In the matter of
Pacific Gas and Electric Company
Diablo Canyon Nuclear Power Plant
Units 1 and 2

Docket Nos. 50-275, 50-323
Draft Supplemental Environmental
Impact Statement
December 16, 2024

**COMMENTS BY SAN LUIS OBISPO MOTHERS FOR PEACE REGARDING
DRAFT ENVIRONMENTAL IMPACT STATEMENT FOR RENEWAL OF OPERATING
LICENSES FOR DIABLO CANYON NUCLEAR POWER PLANT, UNITS 1 AND 2**

High Seismic Hazard and Risk at Diablo Canyon Power Plant Due to Thrust Faulting Under the Irish Hills

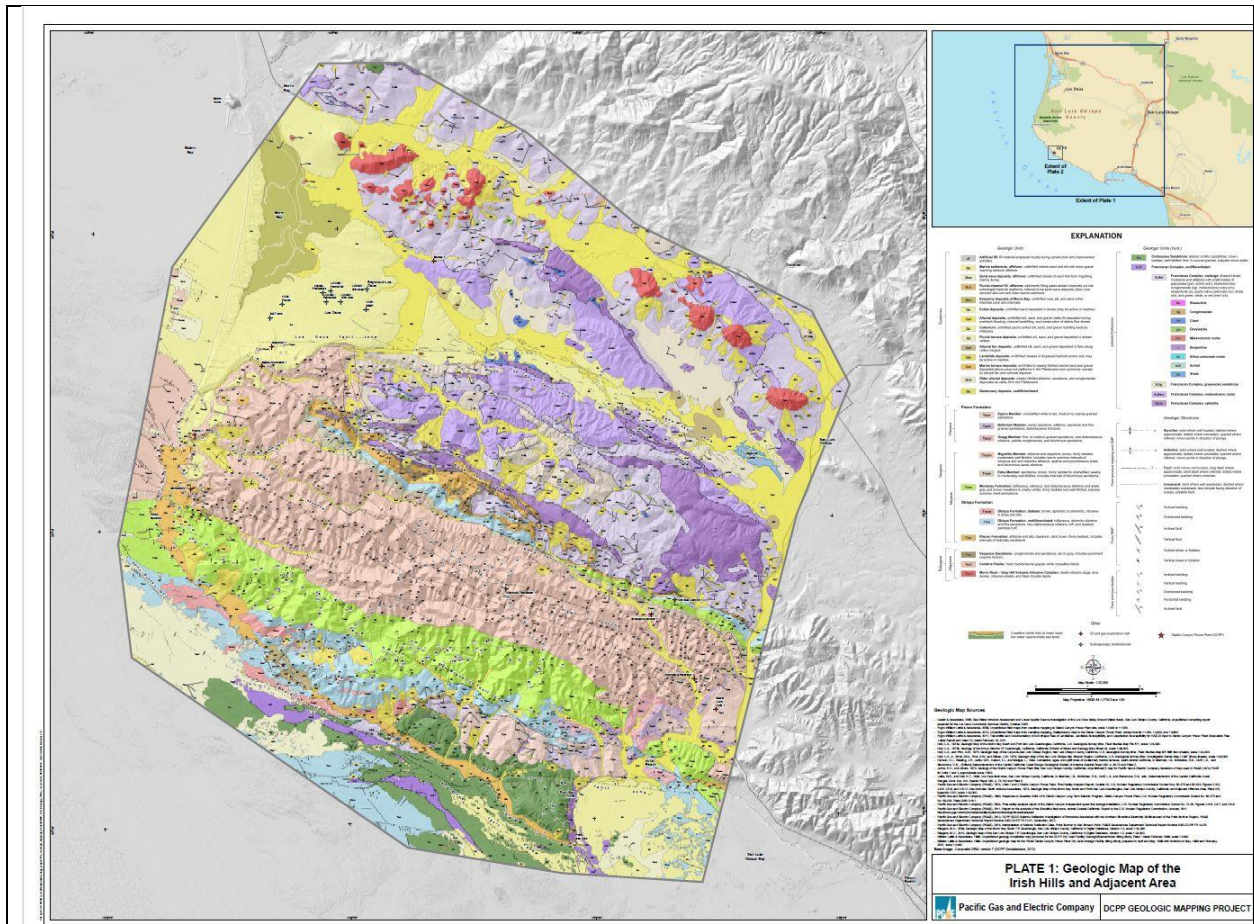
The geologic map (**Figure 1**) shows tight folding of Late Miocene sedimentary rocks has occurred since 6~5 Ma. Therefore, the Irish Hills are not rigid, and additional blind thrust faults are active in the interior.

The Pismo syncline is the primary structural feature exposed in the Irish Hills [*PG&E*, 2014]. Here beds have been rotated $\sim 45^\circ$, which angle is supported by both mapped surface dips in outcrops (geologic map, *ibid*), and by the overall dip of unit Tmo Tertiary Miocene Obispo Formation in the borehole-controlled cross-section of Figure 13-17 of the *PG&E* [2015] SSC. This folding began after deposition of the youngest strata in the core of the fold (Tmpm), and prior to deposition of the Squire Member of the (Pliocene) Pismo Formation (Tpps), probably ~ 5 Ma. This folding implies upper-crustal strains of ~ 0.8 , and mean strain-rates of $\sim 0.8 / 5 \text{ Ma} = 5 \times 10^{-15}$ per second (/s). This is $\sim 10\times$ faster than rates of "off-modeled-fault" (or "continuum") deformation that are typical in the long-term neotectonics of the western US [5×10^{-16} /s per *Bird*, 2009]. This high rate of permanent straining implies a high rate of faulting and of earthquakes, even if the relevant thrust fault traces are not always exposed.

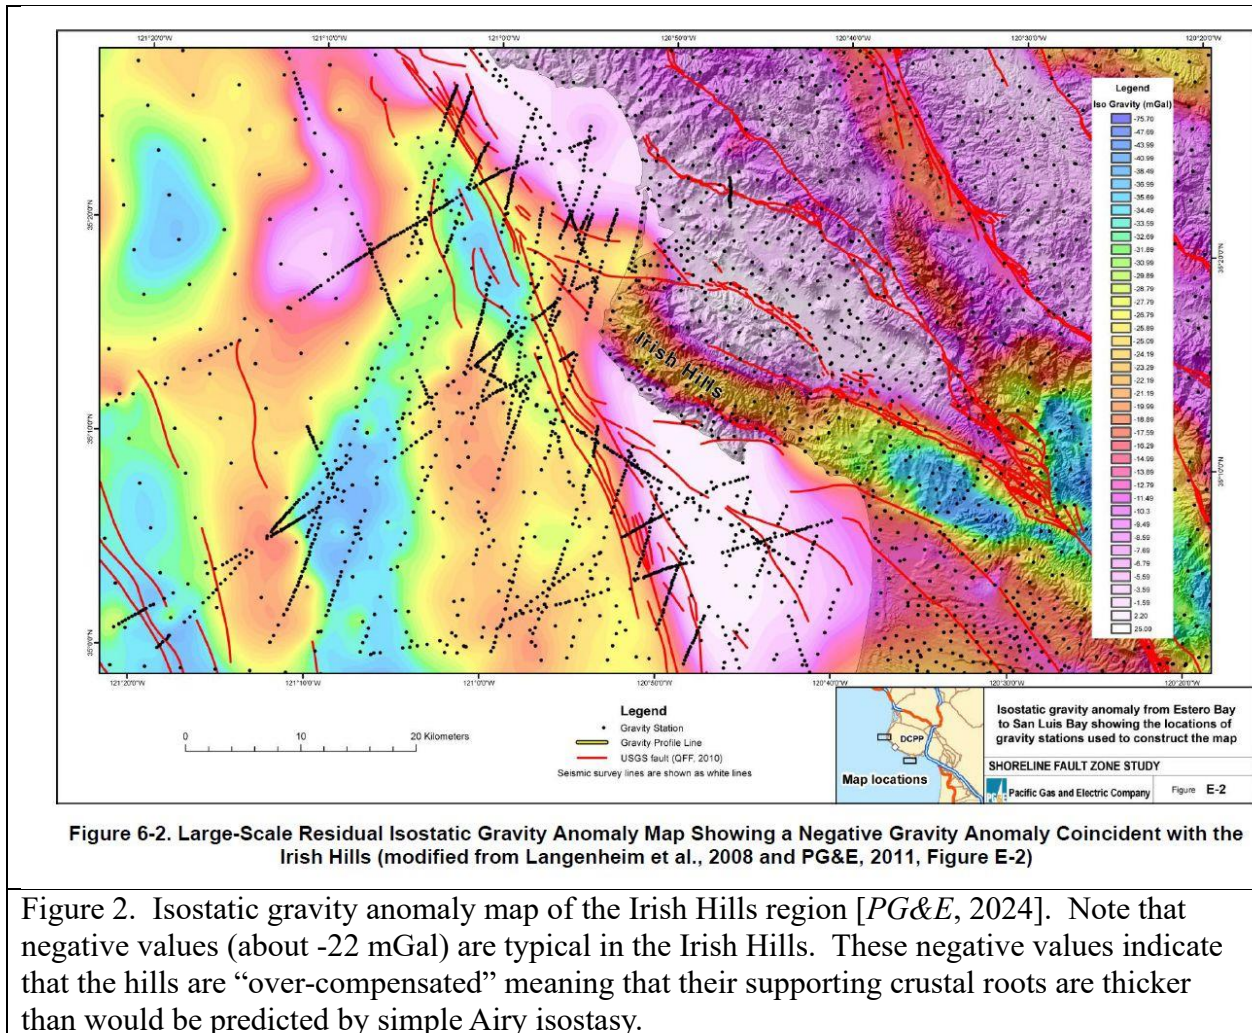
Also, rigid-body uplift would not produce crustal thickening. Therefore, if the Irish Hills were a rigid block, they would have a positive isostatic gravity anomaly. However, gravity data (**Figure 2**) shows a negative isostatic gravity anomaly, indicating more than simple Airy compensation by crustal roots (more than the typical Airy ratio of 6:1).

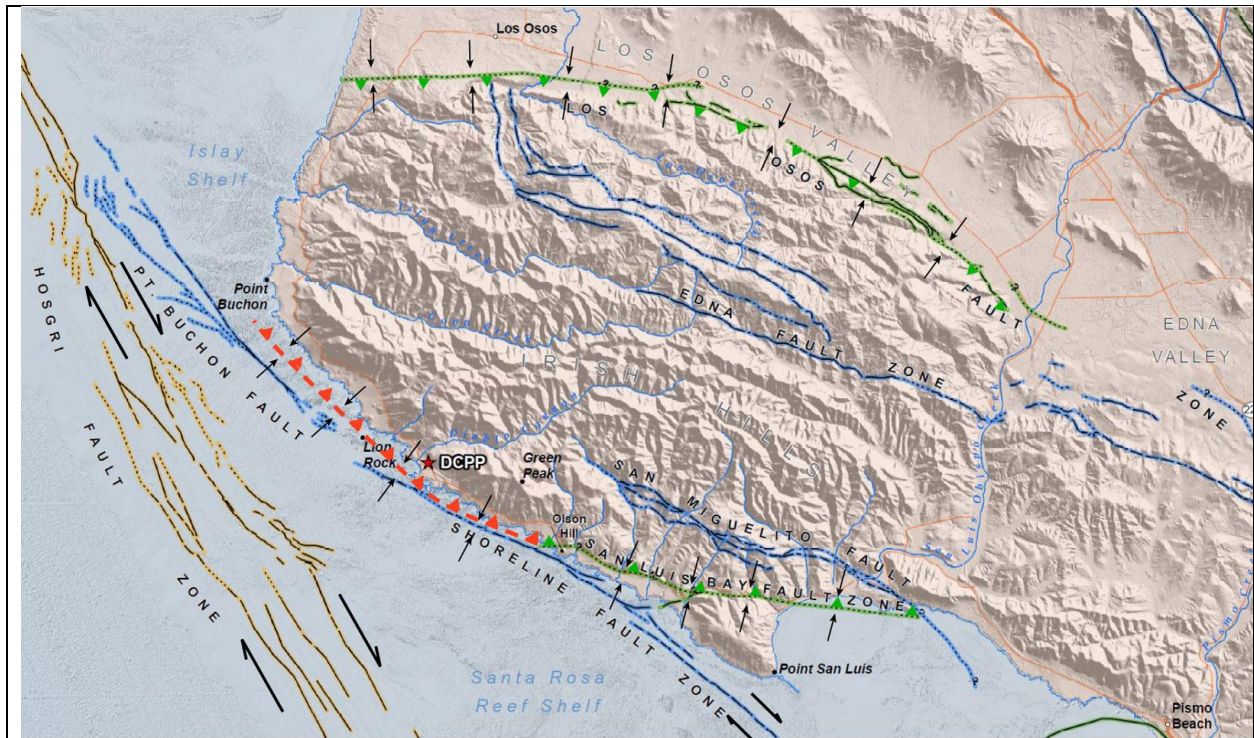
The Irish Hills are being deformed by numerous unmapped and/or blind thrust faults in addition to the 2 thrust faults modeled by *PG&E*. One prominent possibility (**Figure 3**) is the Inferred Coastline thrust fault (my term) passing offshore DCPD along the southwest coast of the Irish Hills, and dipping under the plant. The inferred location of this fault trace is based on: (1) the southwestern front of the Irish Hills is a topographic scarp with a smooth arcuate shape, mirroring the slightly-lower scarp on the northeast which has been formed by slip on the Los Osos thrust fault; (2) the documented uplift of marine terraces on the northeast side, relative to the continental shelf; (3) intense deformation of Miocene rocks in the plant area, which could be

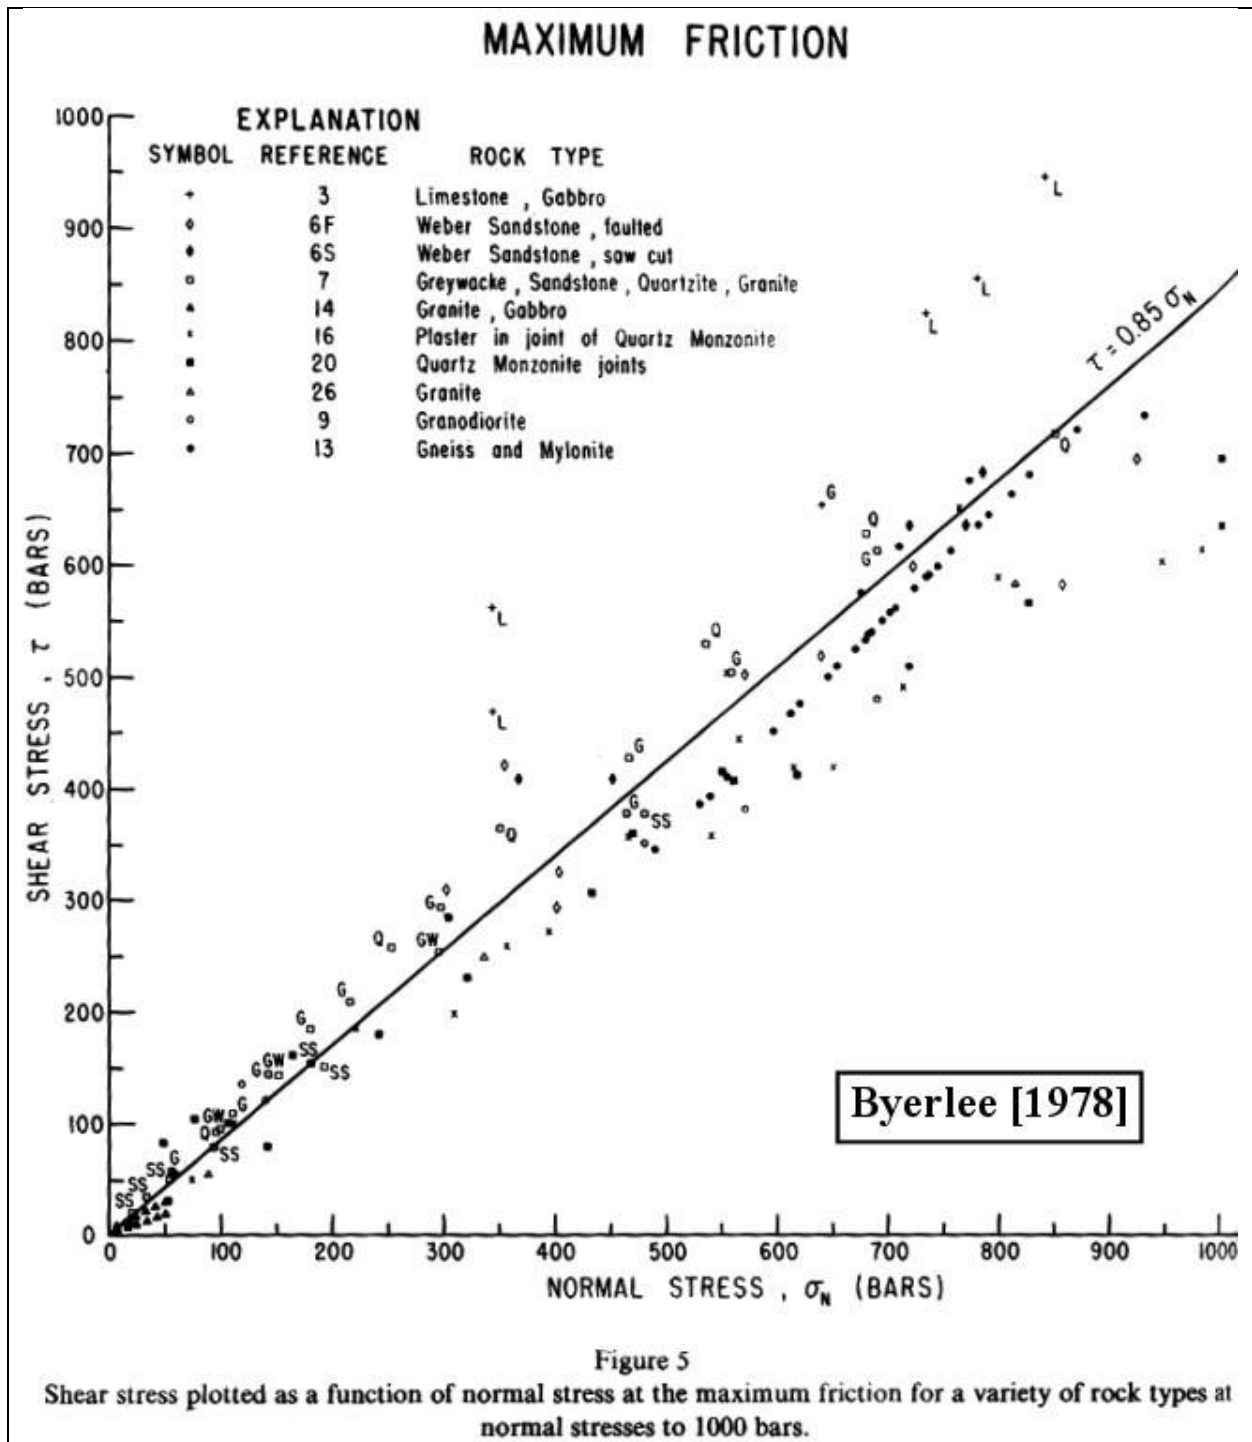
125-year-old Mohr/Coulomb friction theory shows that thrusts never form at dips steeper than 45°, and most commonly dip at ~25° for rock friction coefficient of 0.85 [Byerlee, 1978; **Figure 4**]. This result comes from the simple formula:

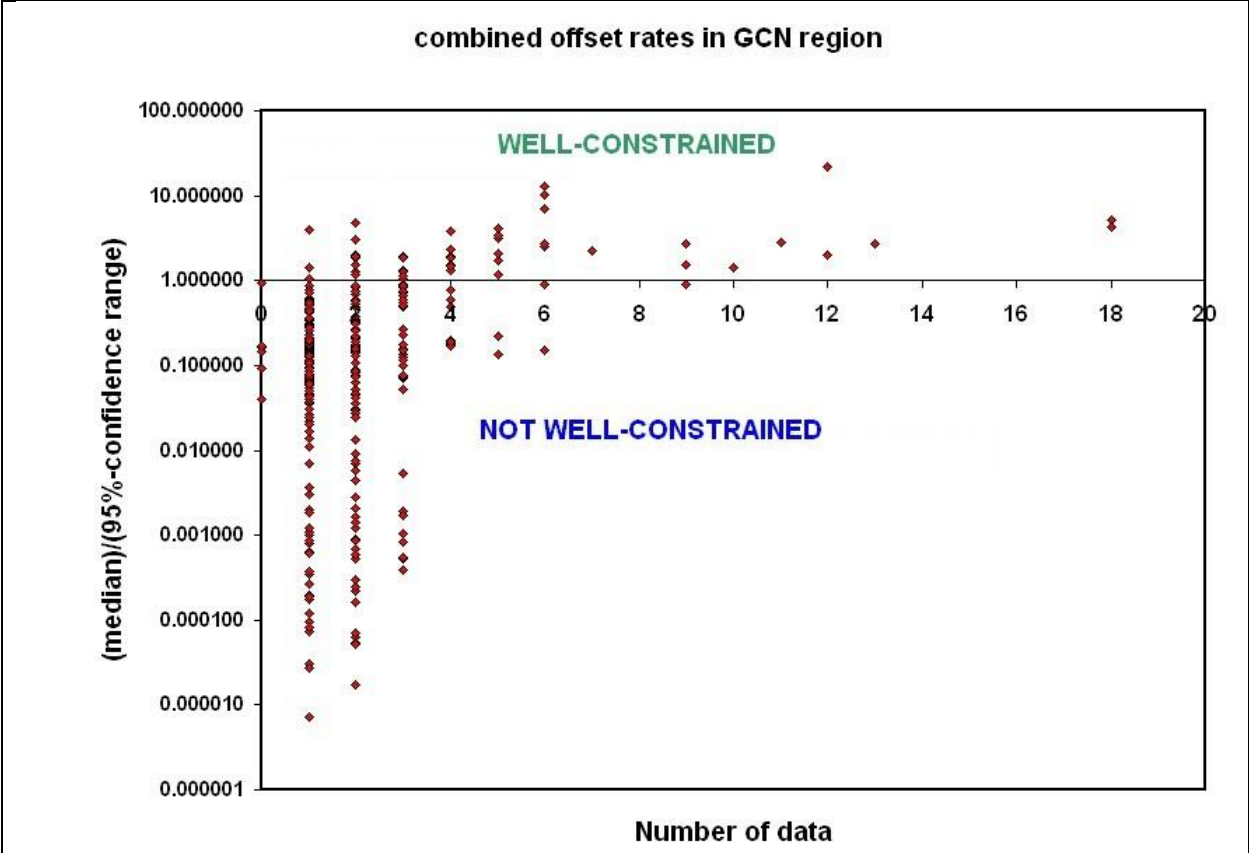
Furthermore, that study concluded that a single offset feature is very rarely enough to make the fault offset rate “well-constrained;” instead, 4 offset features are needed to achieve a 50%-chance that the rate is “well-constrained,” and 7 offset features are needed to guarantee it (**Figure 6**).

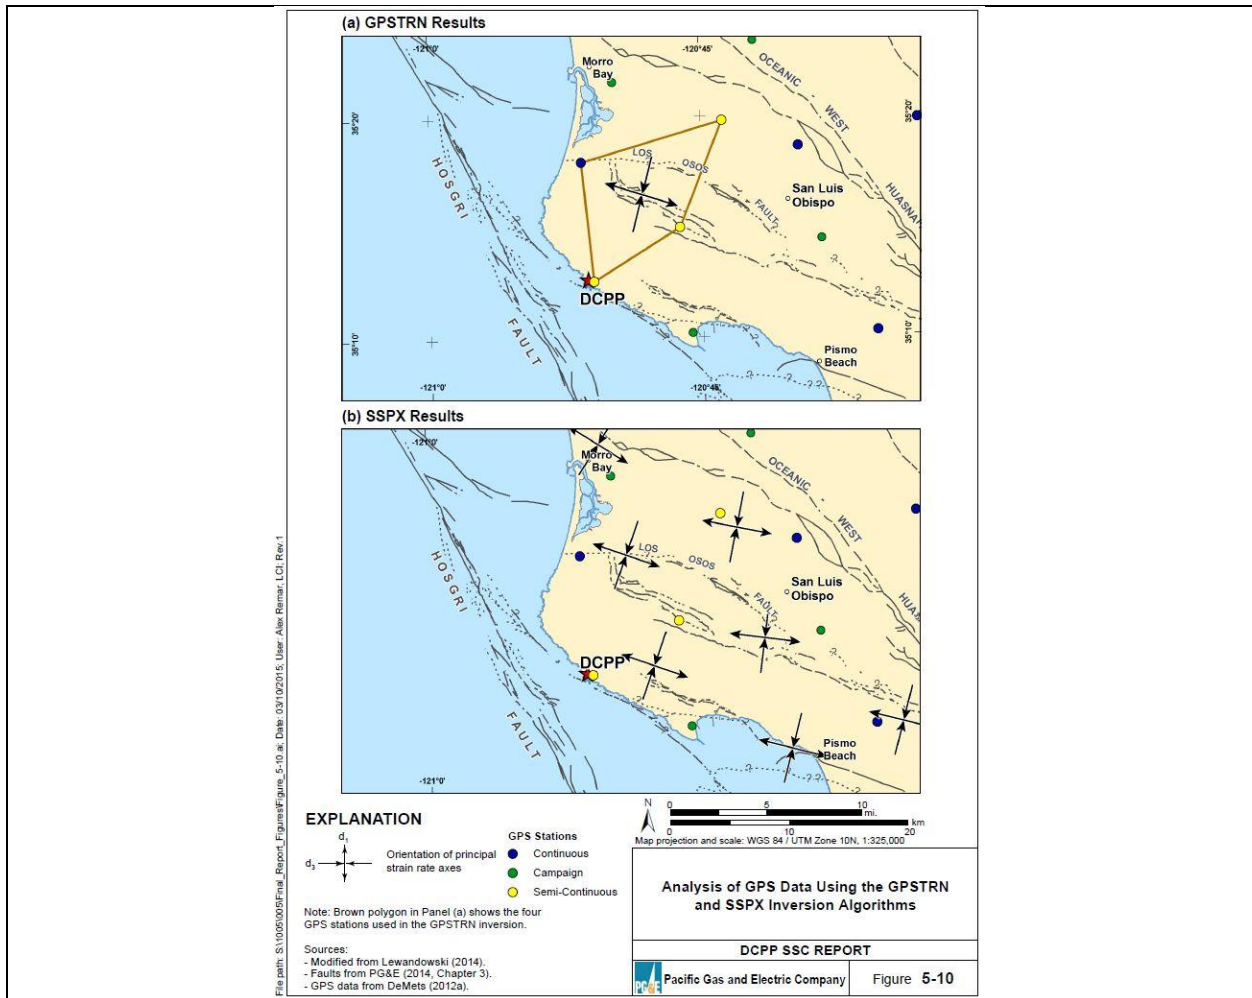
Thus, PG&E was negligent and unprofessional in failing to consider additional geologic constraints from older offset features, such as the once-planar Obispo Formation beds. PG&E should have created one or more structure models showing how this formation (and overlying sedimentary rocks) came to be bent into the present Pismo syncline and other folds in the center of the Irish Hills (**Figure 7**).

I provide one example in **Figure 7**: Throw of the Obispo Formation at the San Luis Bay-Inferred Coastline thrust fault is 1.6~2.2 km since 5 Ma, implying throw-rate of 0.32~0.44 mm/year, and fault slip rate of 0.76~1.04 mm/year.

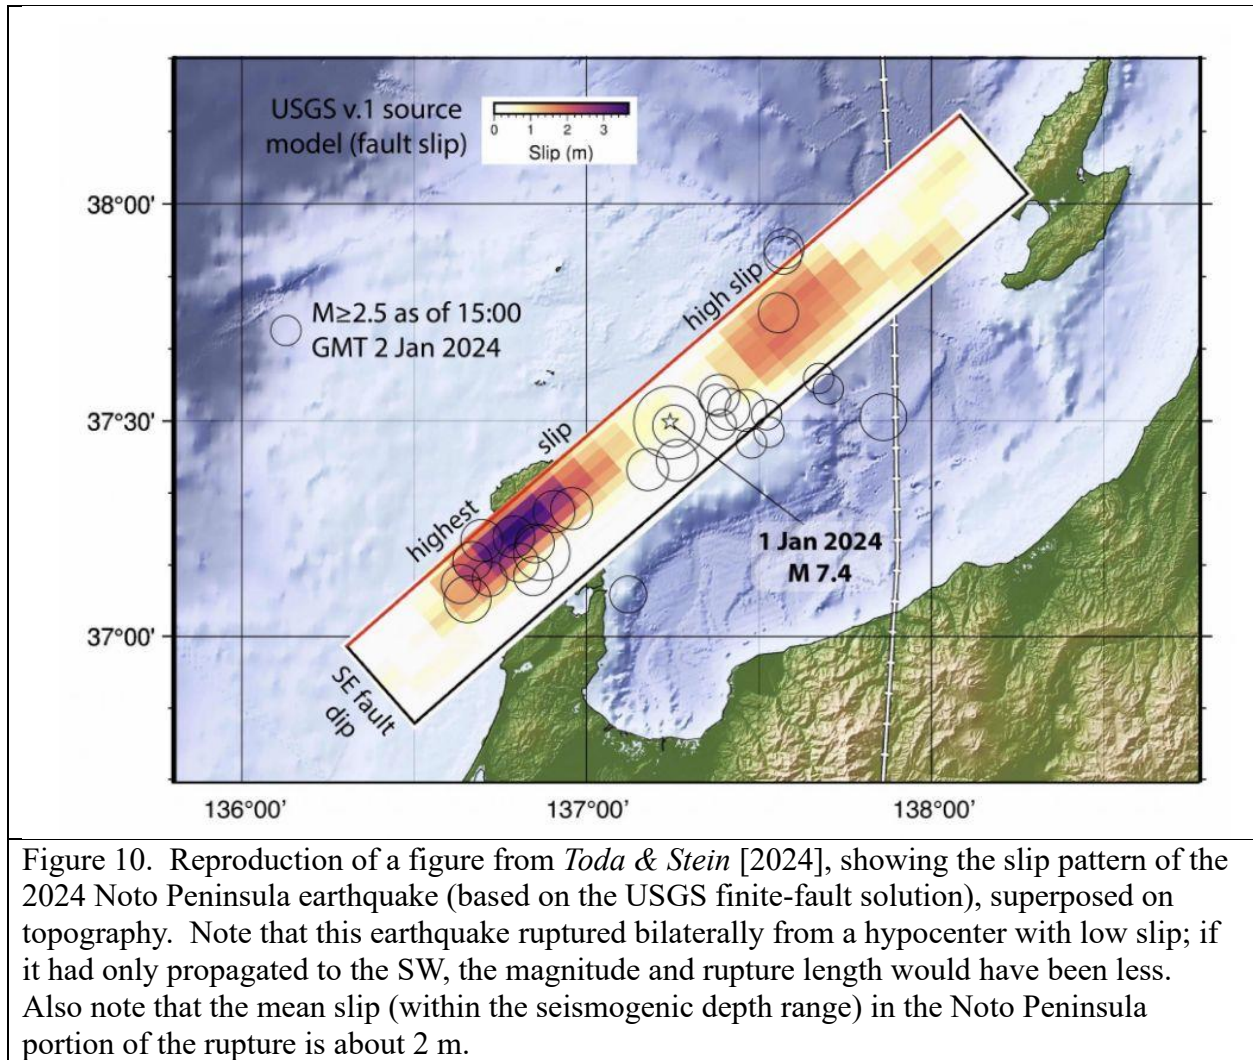
PG&E operated a GPS receiver at DCP, and *PG&E* [2015] reported the shortening direction across the Irish Hills as ~N15°E (**Figure 8**), but did not report the shortening rate. The *PG&E* [2024] update added no new geodetic information, even though an additional 9 years of data should have greatly reduced all uncertainties!

When questioned on this point at recent DCISC meeting, the PG&E representative explained that GPS velocity profiles cannot be used to measure fault heave rates unless the profile of GPS stations extends far from the fault on both sides, and that the coastline near DCP makes this impossible.

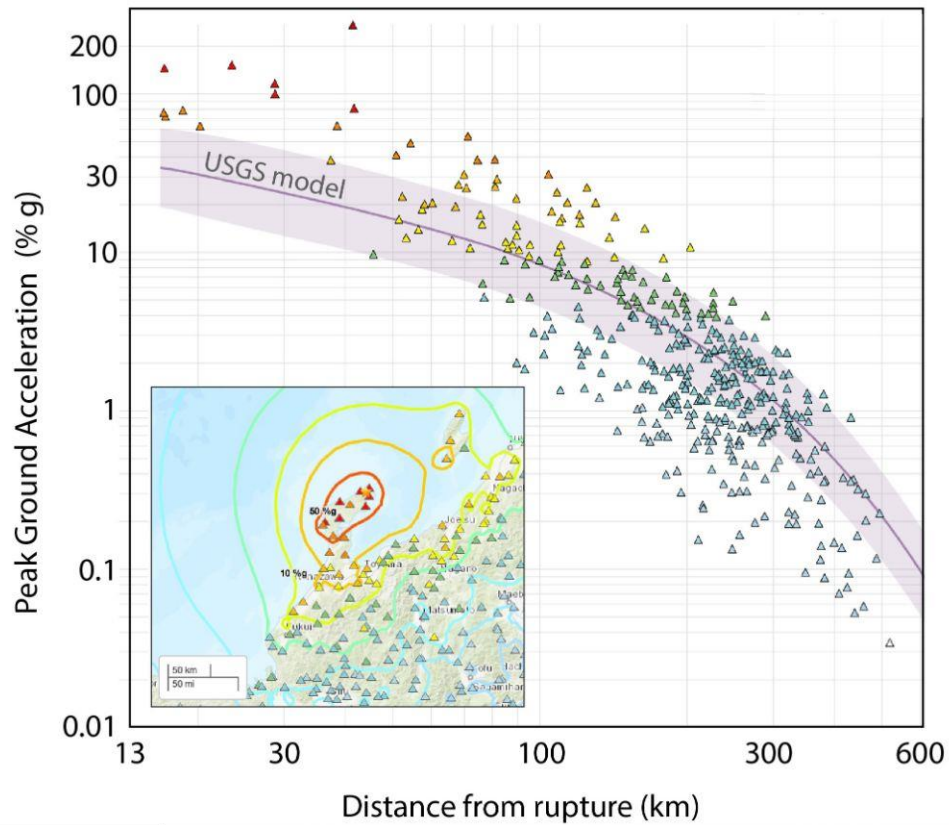
predicted the shaking within 40 kilometers of the rupture by factors of two to five.
